Contract #: 04-0120F4Cty: SF/ALA Rte: 80 PM: 13.2/13.9File #: 69.25B**QUALITY ASSURANCE -- NON-CONFORMANCE REPORT****Location:** Changxing Island, Shanghai, P.R. China**Report No:** NCR-000678**Prime Contractor:** American Bridge/Fluor Enterprises, a JV**Date:** 09-Feb-2010**Submitting Contractor:** Zhenhua Port Machinery Company, Ltd (ZPMC), Changxing Island**NCR #:** ZPMC-0645**Type of problem:**

Reference Description: A few issues were noted for the weld build up on Lifts 6E and 6W Deck Panel Edges at bolted splice connection

Subject: NCR No. ZPMC-0645

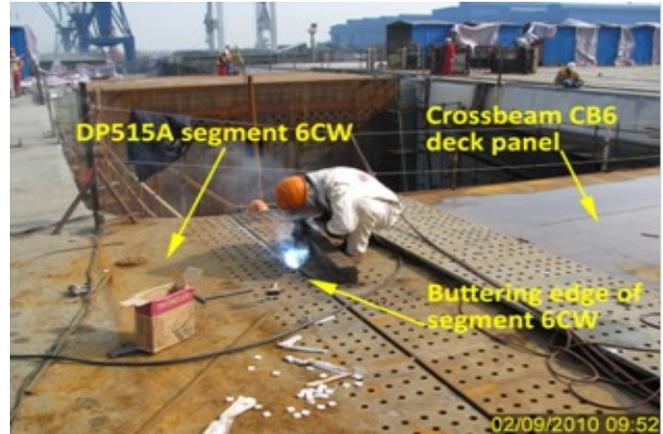
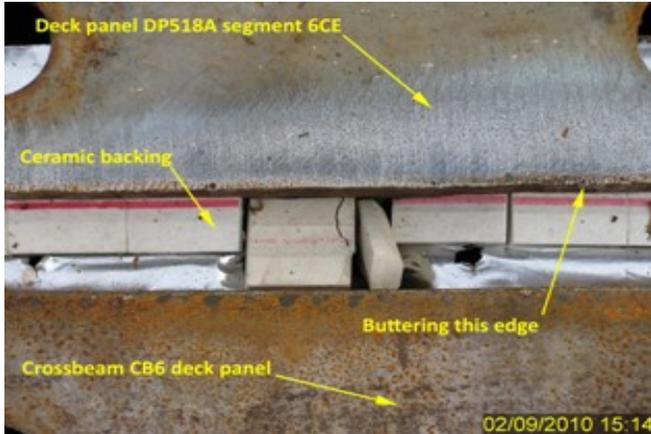
- ZPMC personnel are performing weld build up of the deck panel edge (DP515A and DP518A) by buttering. These edges are to be aligned adjacent to the CrossBeam6 deck panel for the bolted splice connection. The welding procedure was being performed without the prior Engineer's approval. Furthermore, ZPMC personnel did not follow the repair procedures noted in their internal documentation, weld repair report (B-WR 10561).

- Bevel angle noted in "drawing 1" in the disposition of the B-WR 10561 was not observed during the welding operation.
- The type and percentage of NDT inspection to be performed is not known as it is not specified clearly in note 6 of the disposition in B-WR 10561. Furthermore, it is noted that the working drawings do not have a specified weld detail or NDT requirement at this location.

- ZPMC welder performed FCAW of this edge with many times of stop and restart passes without cleaning the "crater area" of the weld prior to resuming the welding process.

Reference Resolution: ZPMC is providing the WRR used at the time and the NDT records to show that the repair is acceptable. Based on this ZPMC requests that this NCR be closed.

This proposed resolution is acceptable. The documentation received is sufficient and the Department concurs that Non-Conformance ZPMC-0645 is closed.

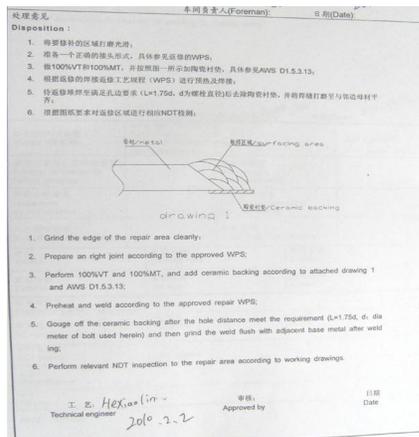
AWS D1.5 2002 section 3.7.4 specifies “Prior approval of the Engineer shall be obtained for repairs to base metal (other than those required by 3.2), repair of major or delayed cracks, repairs to ESW and EGW welds with internal defects, or for a revised design to compensate for deficiencies.”

AWS D1.5 2002 section 3.11.1 “Before welding over previously deposited metal, all slag shall be removed and adjacent base metal shall be brushed clean. This requirement shall apply not only to successive layers but also to successive beads and to the crater area when welding is resumed after any interruption. ”

Reference Description: A few issues were noted for the weld build up on Lifts 6E and 6W Deck Panel Edges at bolted splice connection

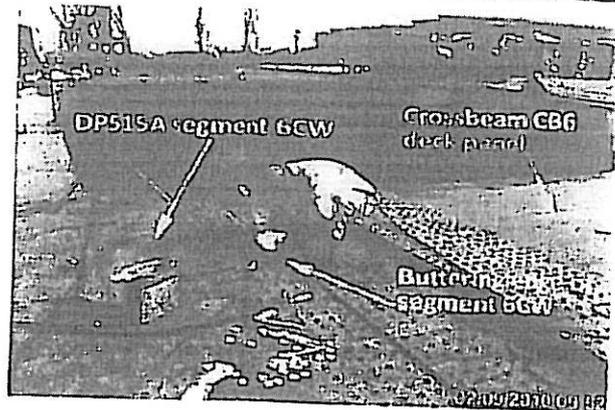
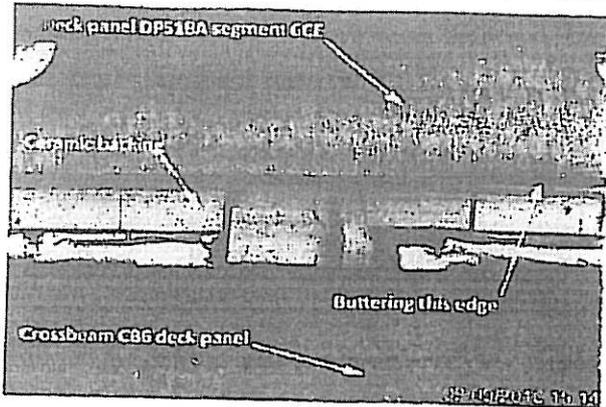
- ZPMC personnel are performing weld build up of the deck panel edge (DP515A and DP518A) by buttering. These edges are to be aligned adjacent to the CrossBeam6 deck panel for the bolted splice connection. The welding procedure was being performed without the prior Engineer's approval. Furthermore, ZPMC personnel did not follow the repair procedures noted in their internal documentation, weld repair report (B-WR 10561).

- Bevel angle noted in "drawing 1" in the disposition of the B-WR 10561 was not observed during the welding operation.
- The type and percentage of NDT inspection to be performed is not known as it is not specified clearly in note 6 of the disposition in B-WR 10561. Furthermore, it is noted that the working drawings do not have a specified weld detail or NDT requirement at this location.

- ZPMC welder performed FCAW of this edge with many times of stop and restart passes without cleaning the "crater area" of the weld prior to resuming the welding process.

焊缝返修位置示意图:

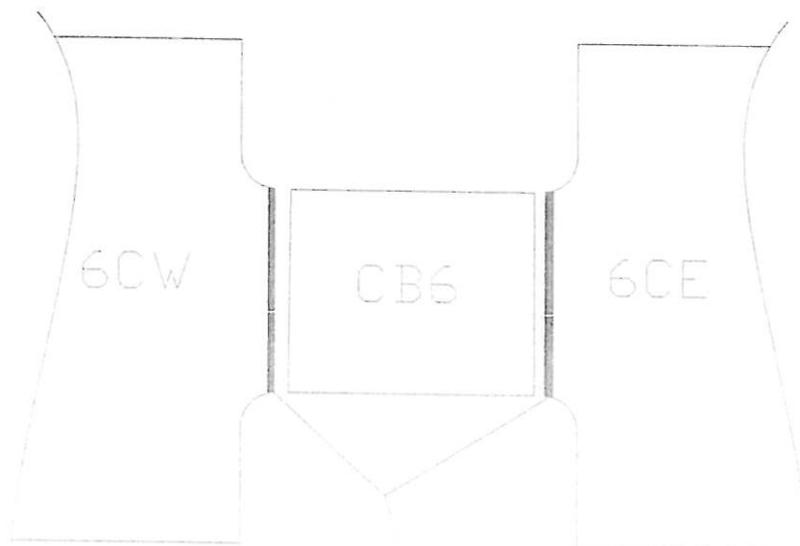
After inspection box 6CE and 6CW and strut plate butt weld, the hole distance size wasn't enough and needed to build up. The detail sees following draft.

1. Grind the edge of the repair area cleanly;
2. Prepare an right joint according to the approved WPS;
3. Perform 100%VT and 100%MT, and add ceramic backing according to AWS D1.5.3.13;
4. Preheat and weld according to the approved repair WPS;
5. Gouge off the ceramic backing after the hole distance meet the requirement ($L=1.75d$, d : dia meter of bolt used herein) and then grind the weld flush with adjacent base metal after welding;
6. Perform relevant NDT inspection to the repair area according to working drawings.
